## ADDENDUM NO. 2

Reference: Solar Thermal System – Swenson Building  
Weber State University – Ogden, Utah  
DFCM Project No. 11004810

Subject: **Addendum No. 2**

Shephard Union

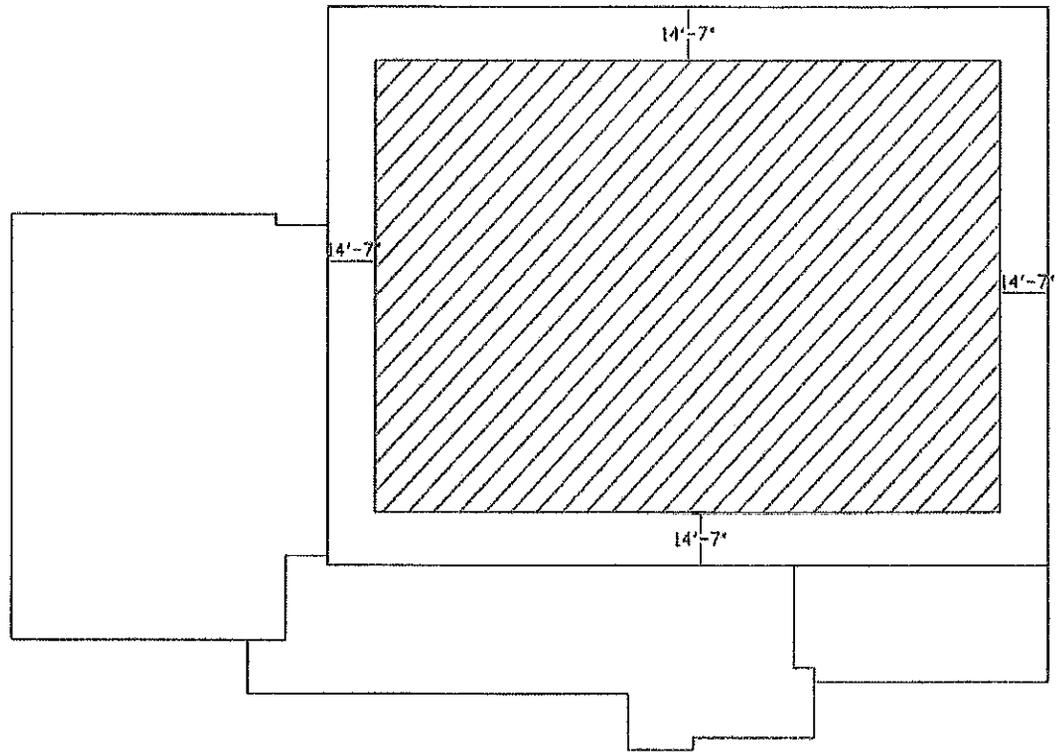
The following figures show minimum setback distances from roof edges, due to increased wind pressures near the edge of the buildings and snow drift locations. Although, it may be possible to install panels in these locations, the wind pressures are generally higher, resulting in heavier anchorage systems and potential for higher amounts of wind-induced damage. The figures below show acceptable areas placement of the panels on a structural basis only.
